**LONGHORN ARMY
AMMUNITION PLANT
KARNACK, TEXAS**

**ADMINISTRATIVE
RECORD**

- E. Title: Report – Draft Final Remedial Action Work Plan, LHAAP-16 Landfill, Final Record of Decision September 2016
Author(s): Department of the Army
Recipient: Environmental Protection Agency
Date: June 20, 2018
Bate Stamp: 00882122 – 00882260

- J. Title: Report – Draft Final, Remedial Action Work Plan, LHAAP-16 Landfill
Author(s): Department of the Army
Recipient: Environmental Protection Agency
Date: July 24, 2018
Bate Stamp: 00882566 – 00882704

Figure 1-3

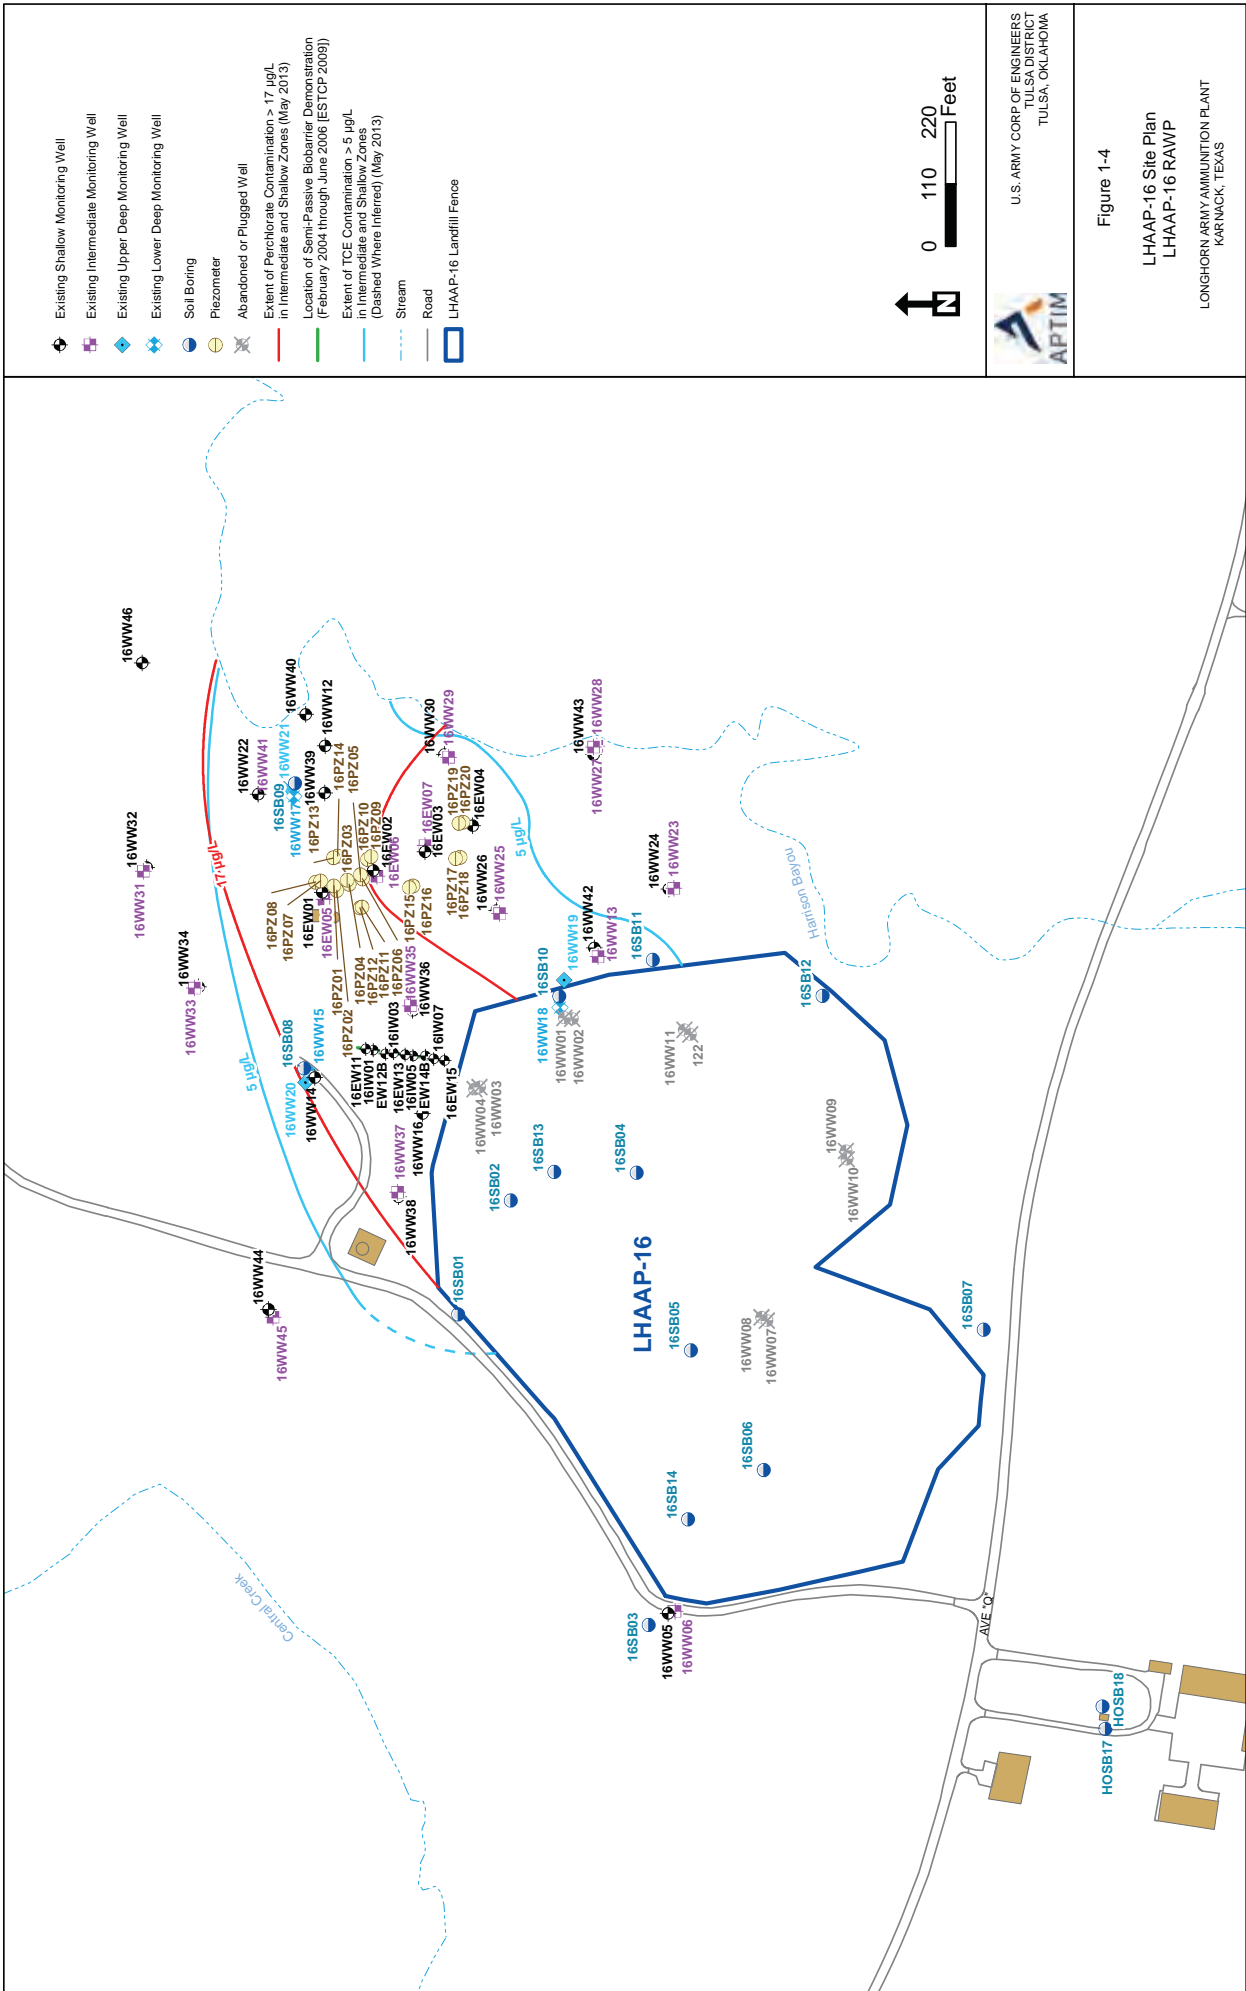
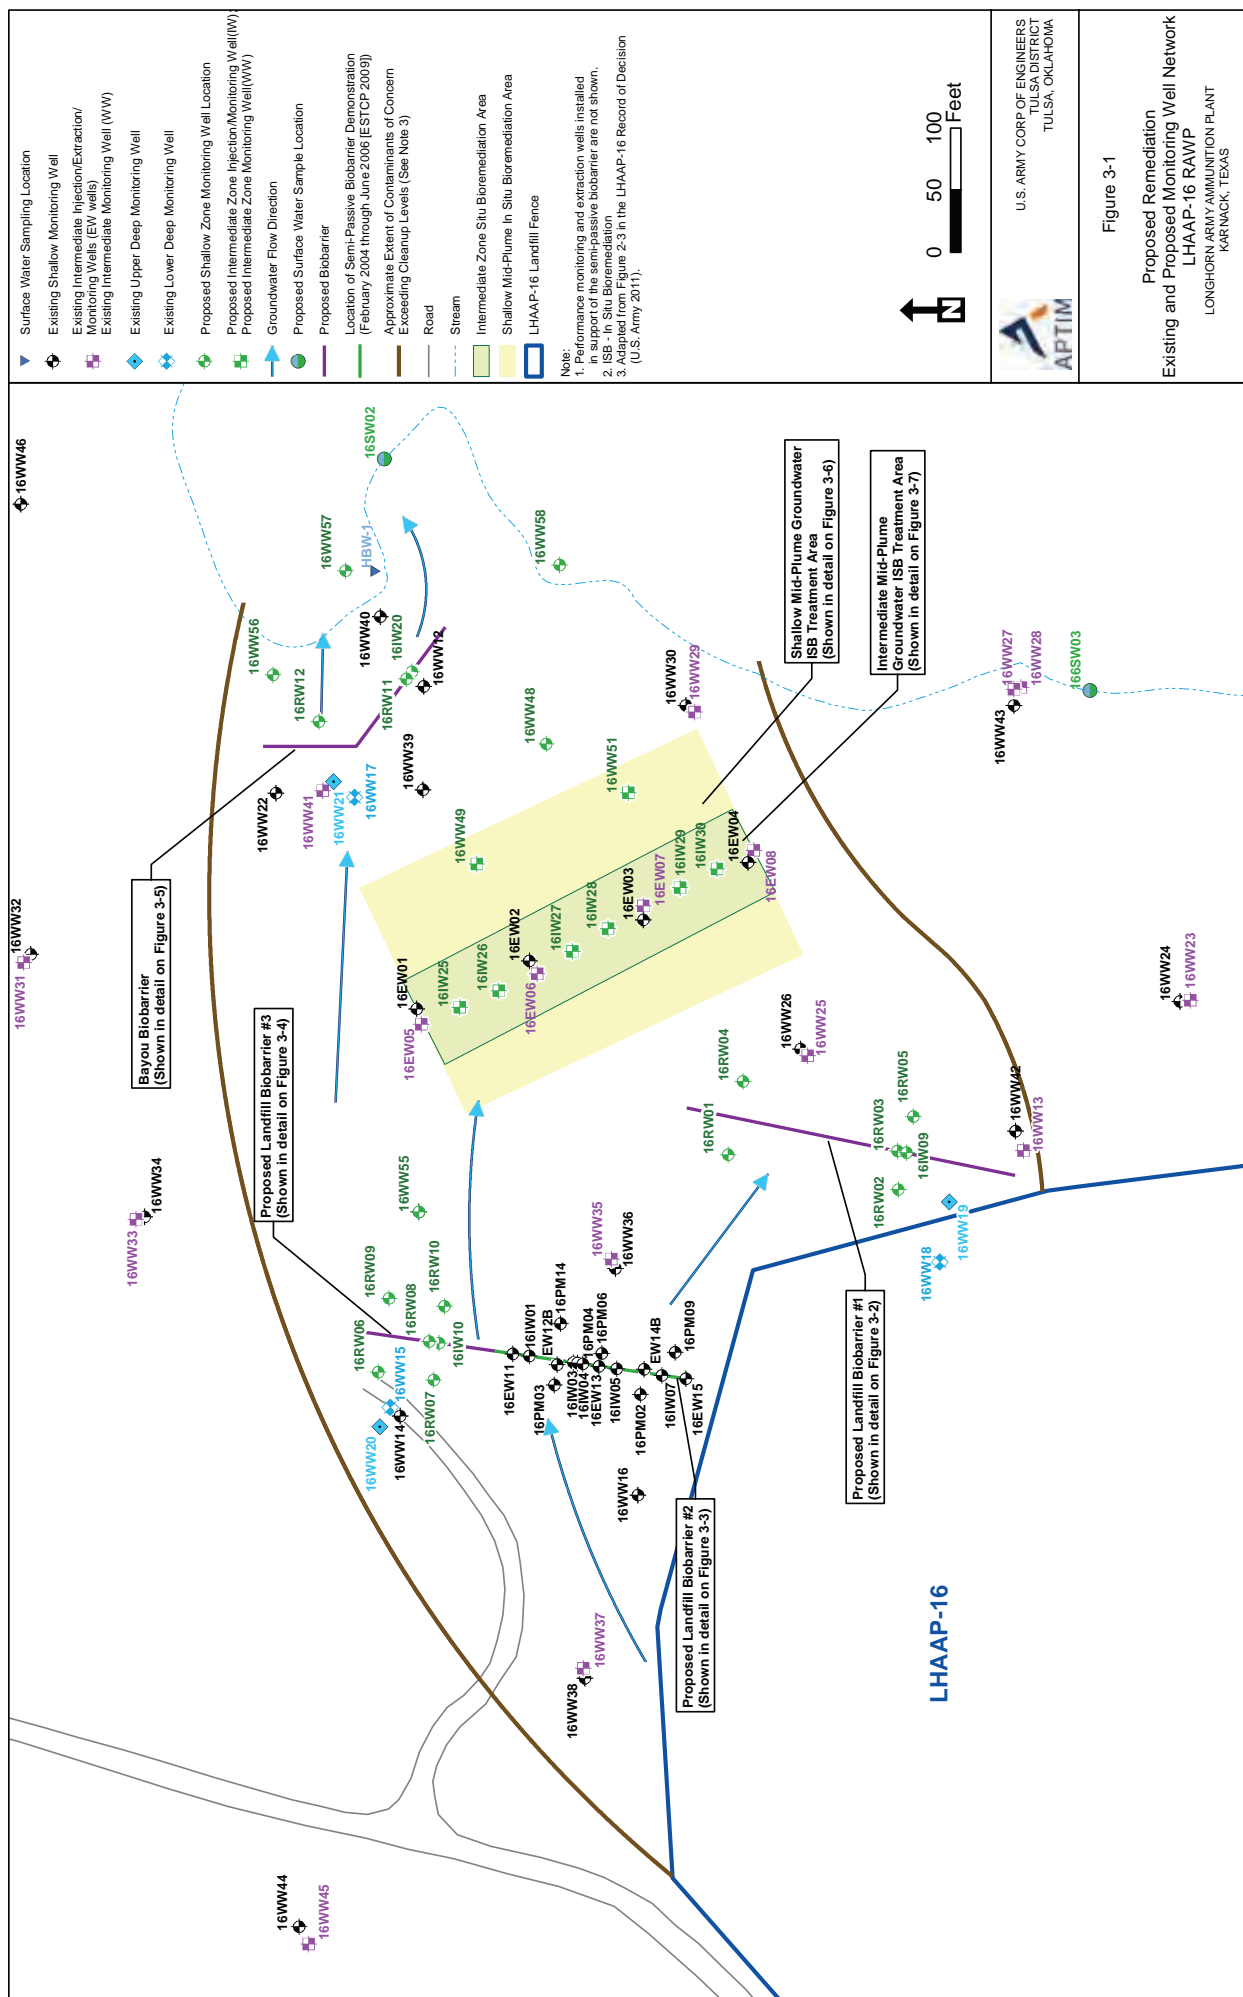
7.	Figure 1-3	In the legend there is a symbol for groundwater wells. Are these considered private home/irrigation wells? Some of these are located on Longhorn. Also, the well by the fire station is not a potable water well as the faucets in the firehouse have non-potable water signs on them.	C	Concur. The wells shown on Figure 1-3 are private wells, wells used for public supply and other wells used specifically by oil and gas companies. We received a comment from TCEQ about Figure 1-3, that the water wells shown on this figure may not be useful for remediation purpose. Figure 1-3 is being revised to remove the water wells, see the response to TCEQ's Comment 11.	A

11.	Figure 1-3	Do the private, public, and installation water wells need to be displayed on this figure? This information is helpful at remedial investigation and remedy selection phases, but not really needed for the remedial action.	C	Figure 1-3 will be revised to remove the water wells shown on the figure.

Figure 1-4
LHAAP-16 Site Plan
LHAAP-16 RAWP
LONGHORN ARMY AMMUNITION PLANT
KARWICK, TEXAS

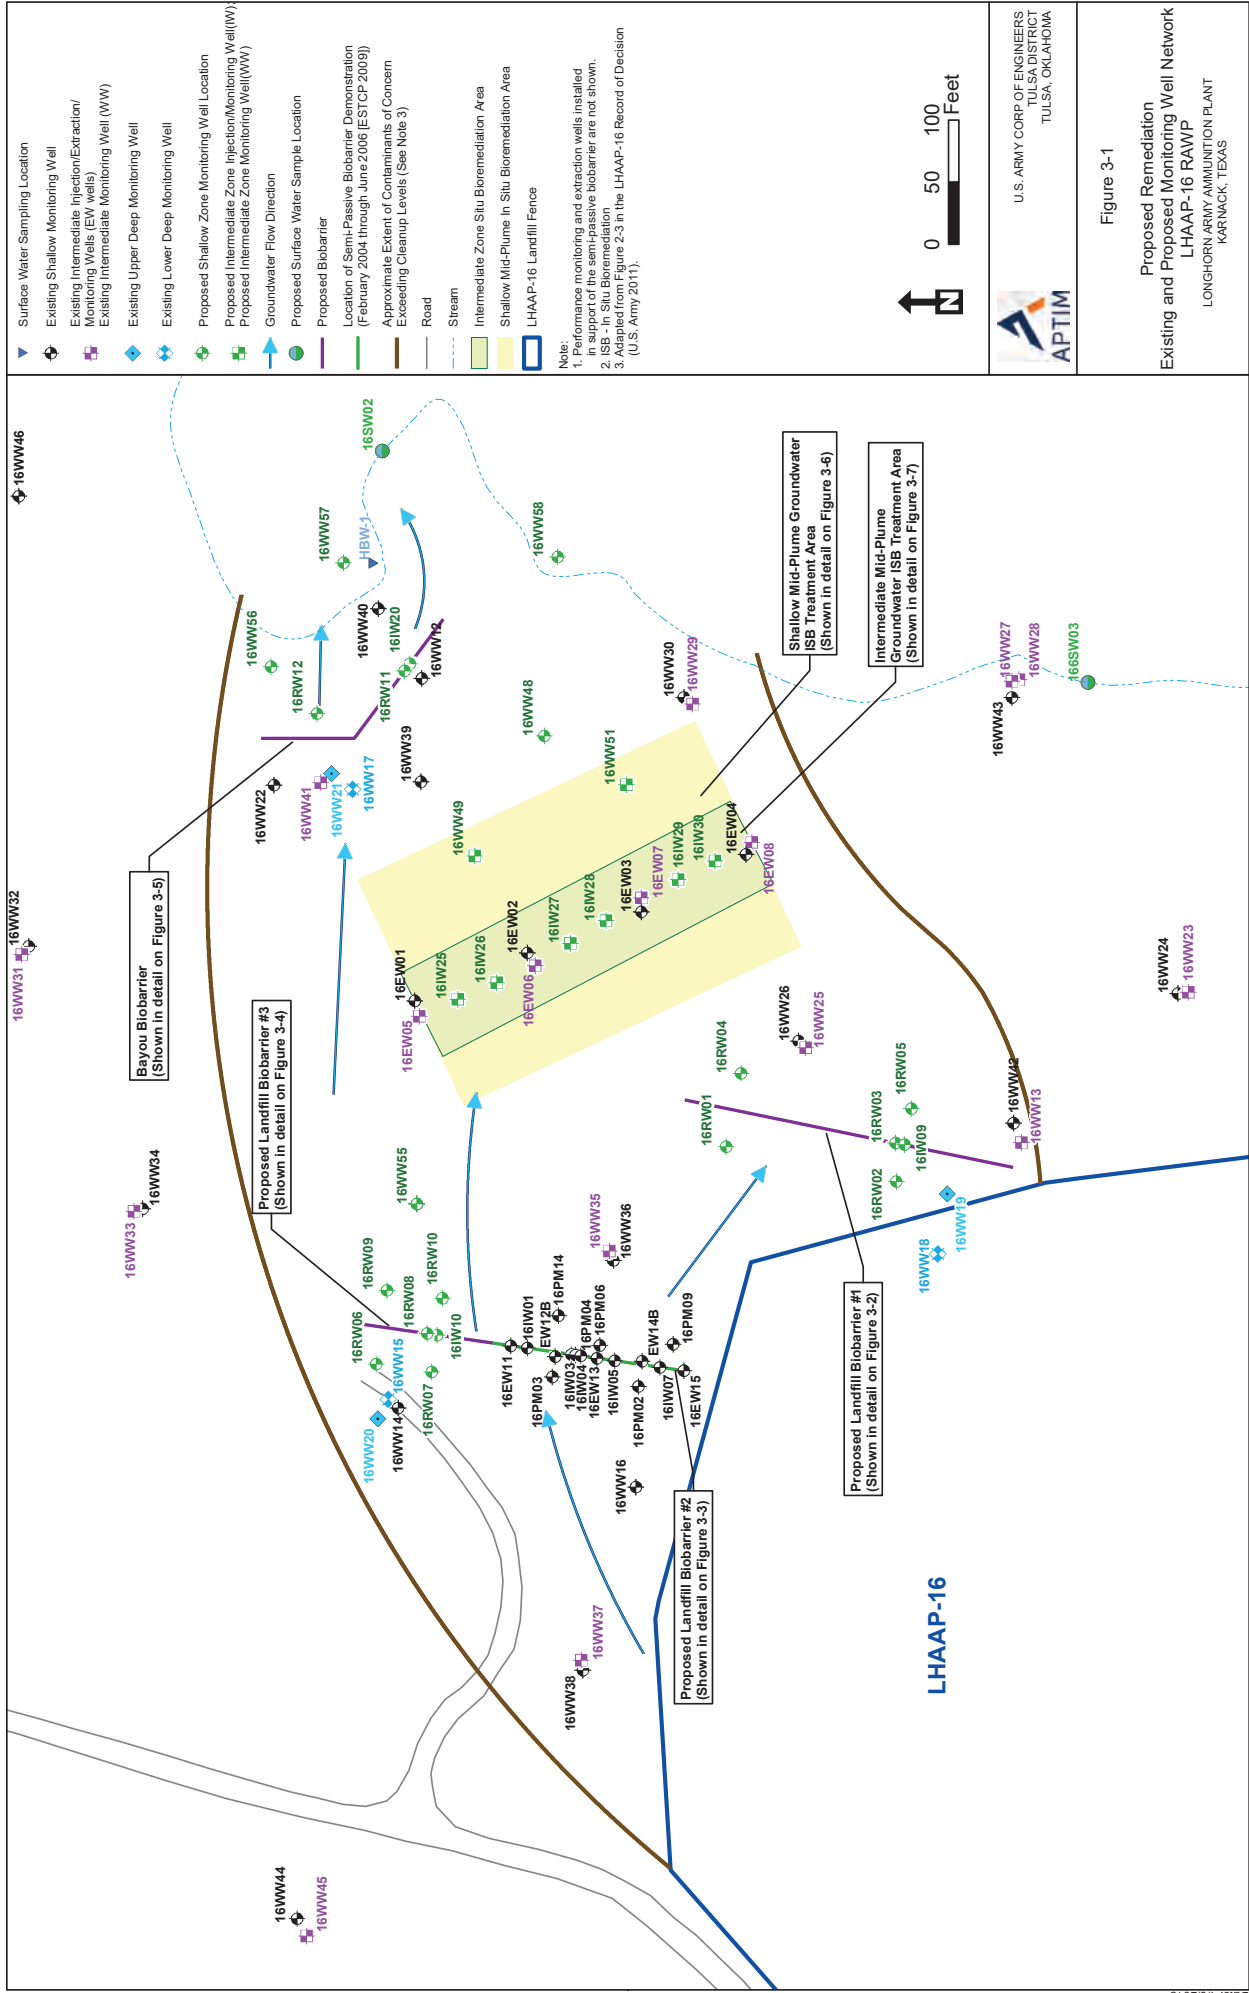
12.	Figure 1-4	Western corner of landfill, wells 16WW05 and 06 are mislabeled. Wells 16WW44 and 45 should be added to this figure (and other relevant figures)	C	Figure 1-4 will be revised to show and label wells correctly.

Figure 4-2
MNA and LTM Monitoring Plan
LHAAP-16 RAWP
 LONGHORN ARMY AMMUNITION PLANT
 KARRACK, TEXAS

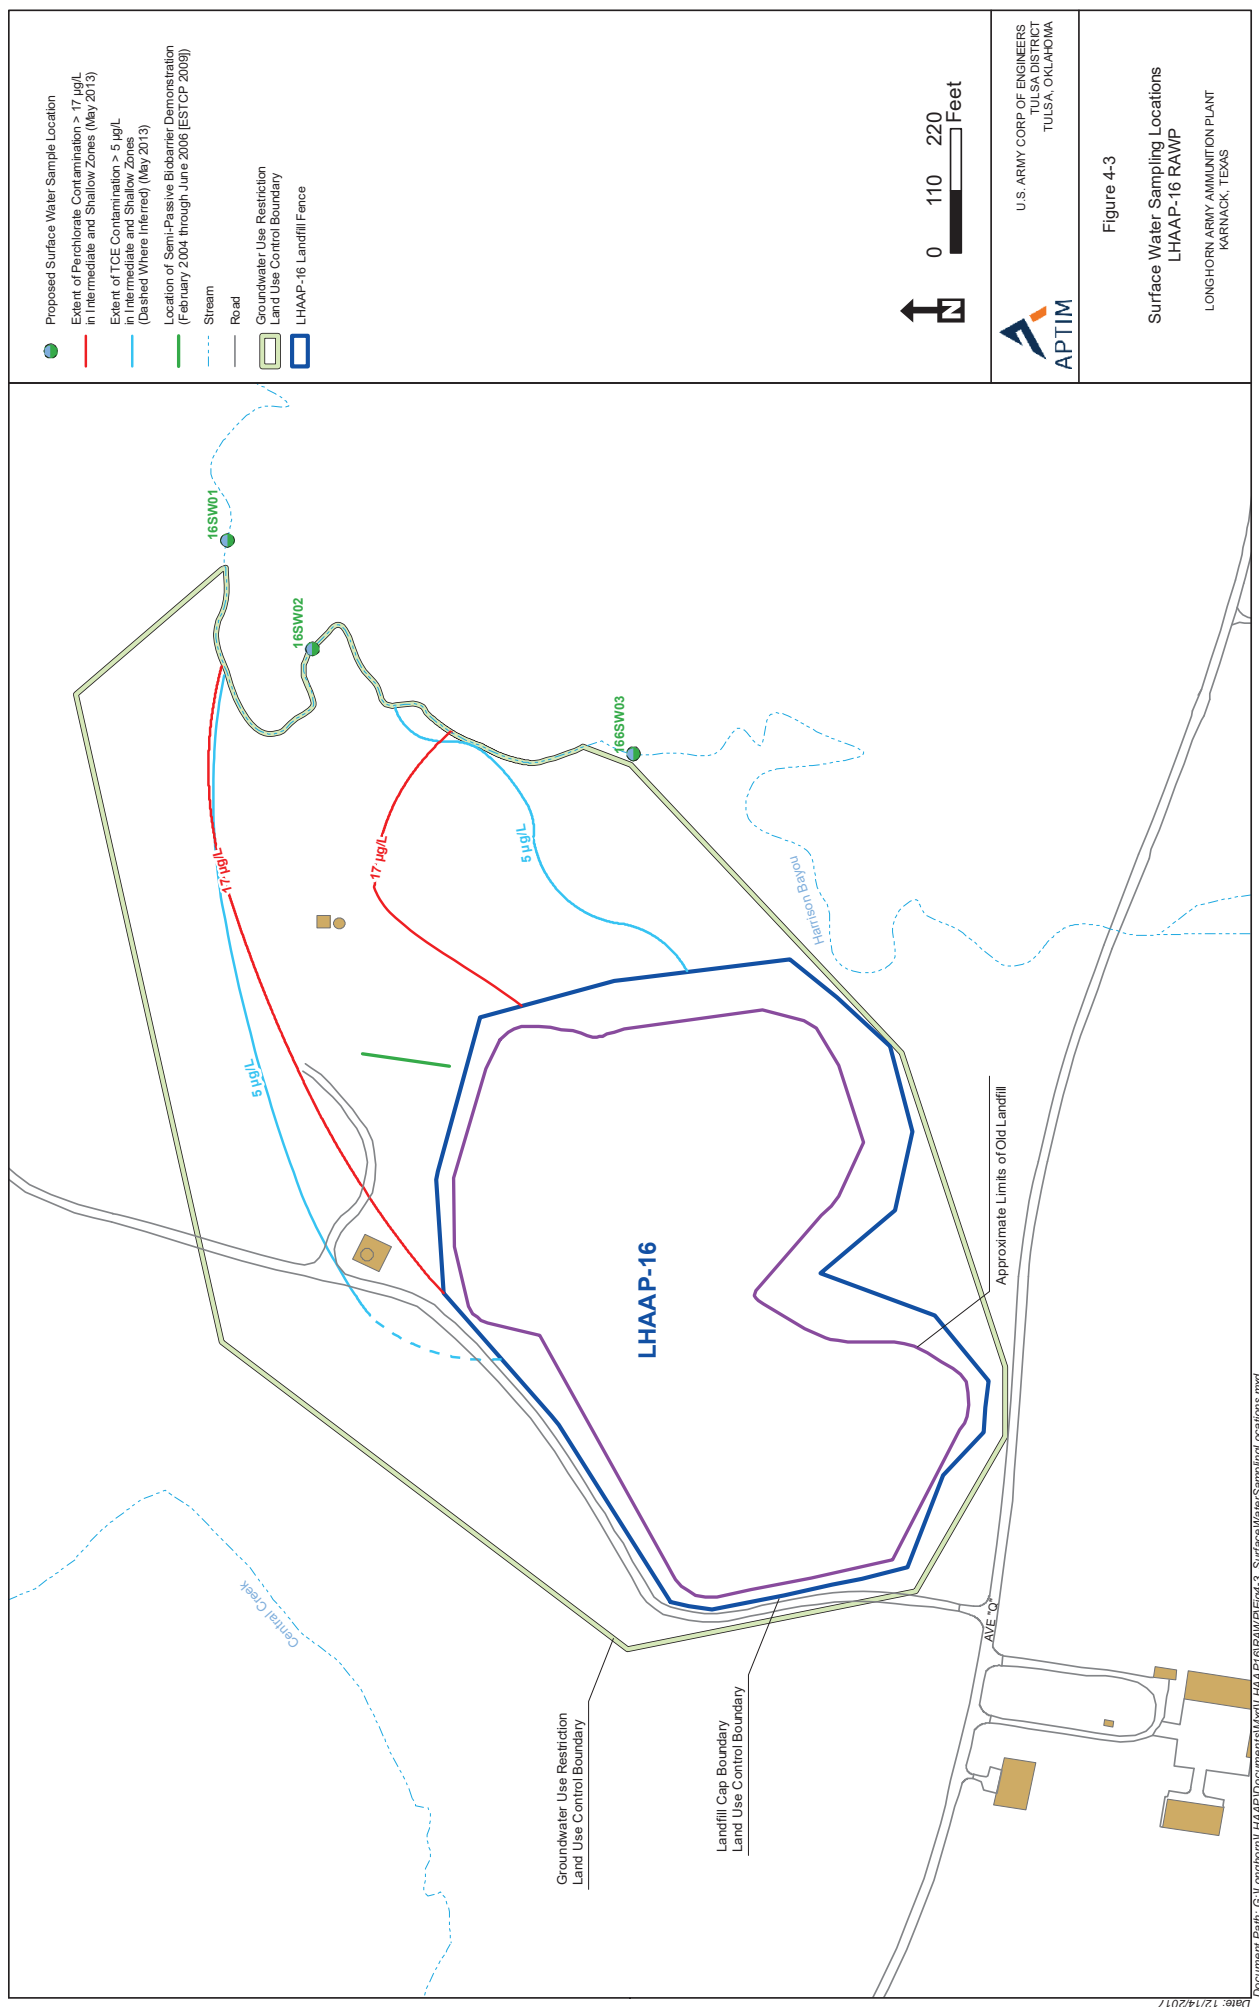
Comment No.	Section/Page/ Paragraph	Comment	C, D, E, or X ¹	Response	A or D ²	Comment
18.	Figure 4-2	Intermediate wells or potentially even deeper wells may need to be drilled on the east side of the bayou due to the intermediate zone contamination currently on the east side of the bayou at monitoring well 16WW41 at 6,650 µg/L of TCE. There is potential for additional migration to the northeast for the intermediate zone.		locations 16SW01, 16SW02, and 16SW03 for VOCs, perchlorate, metals, and field parameters (DO, pH, ORP, conductivity and temperature) as shown in Table 4-10 . Additionally, baseline field readings from the bayou will be collected at locations near the Bayou Biobarrier at least three times during a work day prior to beginning injection into the Bayou Biobarrier.” Noted. EPA made this similar comment during the RD review indicating that a well might be needed at some point in the future. However, at this time, no plans for an intermediate zone well on the east side of the bayou have been made until additional data is collected as part of the implementation and monitoring of the in situ bioremediation. See below for EPA’s comment 17 from the review of the Remedial Design. “EPA agrees with the additional shallow wells proposed by TCEQ shown on revised Figure 4-1. Also, EPA recognizes there may be a need for additional intermediate groundwater monitoring wells in the future, especially in the outer eastern reaches of the plume.”	A	Evaluation of the data obtained during and after the implemented treatments should provide insight for any future actions.

Comment Ref. #	Section, Page Ref.	TCEQ Comment	C, D, E, or X ¹	Response	A or D ²	Army Comment
13.	Figure 3-1	Wells 16WW44 and 45 should be added to this figure (and other relevant figures) These data points are also missing from figure: 16RW07, 16IW04, 16IW09, and 16EW08	C	Figure 3-1 will be revised to show the missing wells.		
14.	Figure 3-3	16IW04 is mislabeled (16IW-4)	C	Figure 3-3 will be revised to correct the mislabeling.		
15.	Figure 4-2	It would be better to have all permanent wells on this figure. Would it be possible to turn on the other wells? The MNA and LTM wells could be shaded/highlighted OR the wells not being used could be faded out. It would also be helpful to have the biobarrier lines drawn for reference (without details)	C	Figure 4-2 has been revised accordingly and is attached to the RTCs.
